MIDORI PRECISIONS CO.,LTD.

Process Change Notification

Model change of LP-50F series

September 30, 2014

Annex. 2 LP-50FB

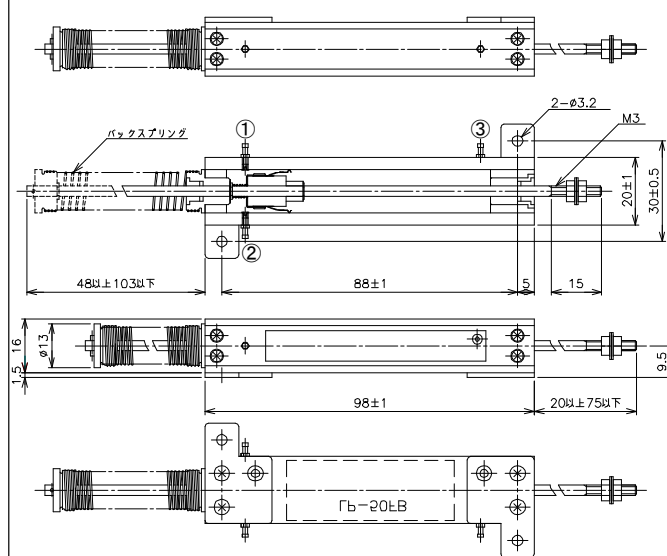
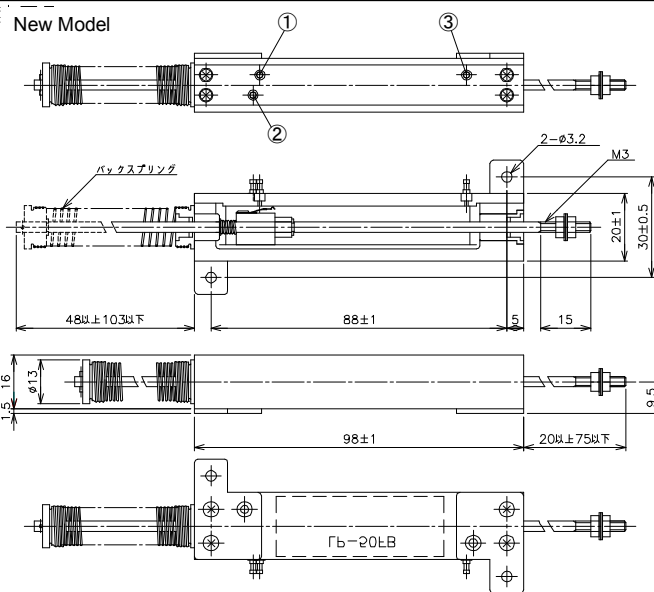
1. Housing material will be changed to Aluminum die casting and its surface anodized.
(Color: Black)
2. Improvement in reliability of shaft play by changing slider and wiper design.
3. Collector part will be placed to element side. Then terminal pin will be changed.
4. Electrical and Mechanical specifications will not be changed.
5. Mounting positions will not be changed.
6. Resistance value : 500ohm will be discontinued. 10kohm will be added.
7. Shaft starting friction force will be changed. (ex. LP-50FB: from 0.4N approx. to 0.8N approx.)
